**Letter of Objection – Cockle Bay Wharf mixed use development – SSD-9978934**

### RE: COCKLE BAY PARK REDEVELOPMENT – SSDA REVIEW

A high-level review of the Cockle Bay Park Redevelopment State Significant Development Application (SSD-9978934) documentation was completed to understand any construction or operational traffic impacts of the proposal on The Ribbon development.

Figure 3: Cockle Bay Park Reconfiguration

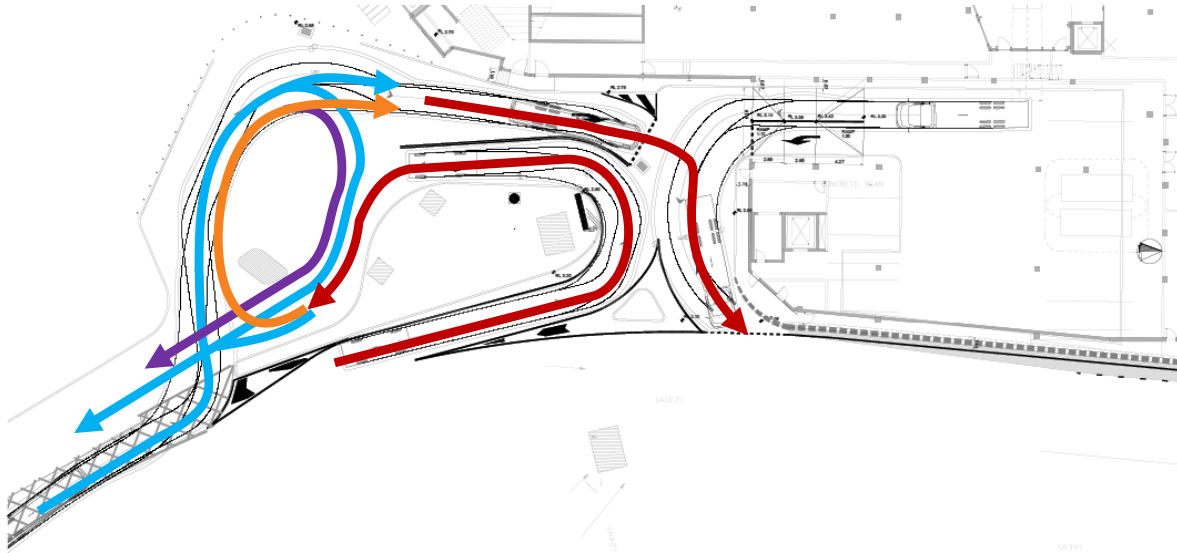
- The proposal creates another short deceleration lane from Harbour Street with traffic required to slow to a walking pace and complete a U-turn to access The Ribbon. The current Wheat Road slip lane design allows vehicles to diverge and subsequently slow further away into Wheat Road away from Harbour Street. The shortening of the deceleration lane along with the S-bend arrangement to access the Cockle Bay loading dock may create a safety concern.

- The proposal for cars to entry via the new Harbour Street/ Wheat Road intersection requires cars to use the loop road to circulate for set-down/ pick-up activities. The loop road is controlled by a customised signal system to manage two-way, one lane traffic along the link road between the loop and loading dock, with the intent that it is only used by valet drivers and service/ delivery vehicles who are inducted on the operation. Although the proposal increases queuing capacity for The Ribbon porte cochere, there could be potential confusion from the public understanding the signal system and drivers will be held up/ delayed within the loop road (by confusion and signals), resulting in extended queuing.

- The Cockle Bay loading dock access does not provide independent two-way access for trucks and with no sight lines between entering and exiting vehicles, it could result in potential conflict, the need for vehicles to reverse and/or queuing.

- There is limited opportunity to provide a signal system to control the Cockle Bay access. Aurecon show queuing leading up to the loading dock, however such queuing is not really available in the current design, without impacting car entry to and exit from the Ribbon

- Considering the above, all vehicle entry relating to The Ribbon should be retained per the Greaton proposed arrangement via a single shared entry point, with The Ribbon car entry arrangement proposed by Cockle Bay Park removed.
